# Work Order ID 80238

Item Name: 205 Skidtube bent detail

DRAWING NO. D2580	TITLE 205 SKIDTUBE ASSEMBLY	REV. E	<b>DART AEROSPACE LTD ENGINEERING ORDER</b>	D.E.O. NO. D2580-E-1	SHEET NO. SHEET 1 OF 1	SCALE NTS
DRAWN <i>UP</i>	CHECKED <i>ASS</i>	MFG. APPR. <i>ER</i>	APPROVED <i>#</i>	DE APPR. <i>#</i>		
DATE 11.12.13	DATE 11.12.13	DATE 11.12.13	DATE 11.12.13	DATE 11.12.13	DATE 11.12.13

CHANGE ALL C'BORED WELDED CROSSBOLT SPACERS TO SWAGED SPACERS

**SECTION B-B, F-F, I-I**  
NOT TO SCALE

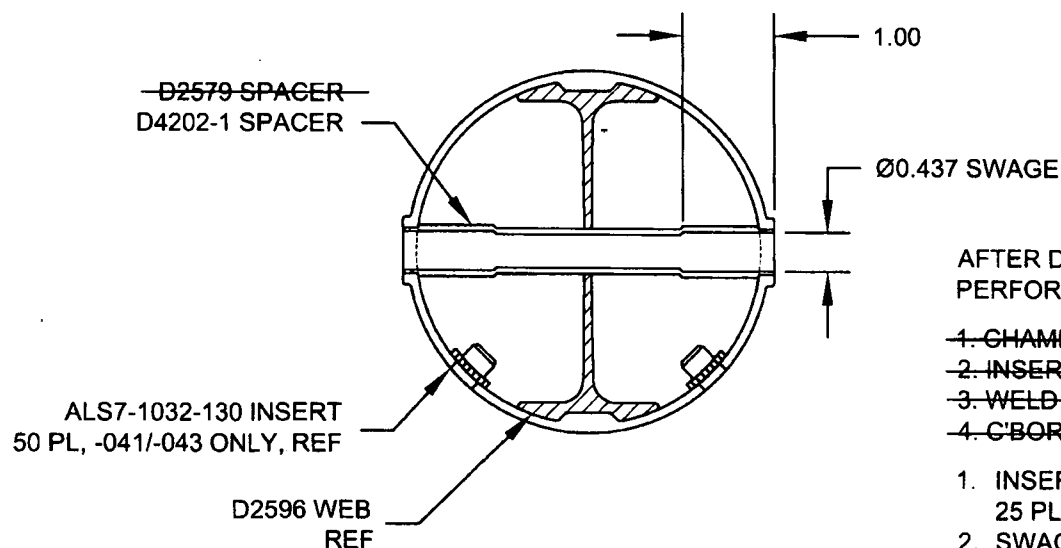
PARTS LIST IS AMENDED AS FOLLOWS:

**WAS**

QTY	QTY	QTY	PART NUMBER	DESCRIPTION
-041	-045	-047		
20	24	25	D2579	CROSS BOLT SPACER

SECTION B-B, SECTION F-F, & SECTION I-I ARE AMENDED AS FOLLOWS  
FOR ALL HOLES THAT WERE ORIGINALLY C'BORED:

AFTER DRILLING AND BENDING ASSEMBLY  
PERFORM THE FOLLOWING FOR Ø0.508 HOLES ONLY:

1. CHAMFER HOLE 0.060 X 45°
2. INSERT D2579 SPACER (20 PLACES)
3. WELD INTO PLACE AND GRIND FLUSH
4. C'BORE D2579 SPACER TO Ø0.437 X 1.00 DEEP

**IS**

4		* D2579	CROSS BOLT SPACER
20	20	25	D4202-1	SPACER

**\* FOR -045 SKIDTUBE ONLY:**  
WELD 4X D2579 SPACERS PER DWG  
IN LOCATIONS MARKED "NO C'BORE".  
REF SHEET 4 OF DWG.

1. INSERT D4202-1 SPACER, 20 PL (-041) OR 20 PL (-045) OR 25 PL (-047)
2. SWAGE TO Ø0.437 X 1.00 DEEP PER QSI 002
3. TRIM / GRIND FLUSH PER QSI 002
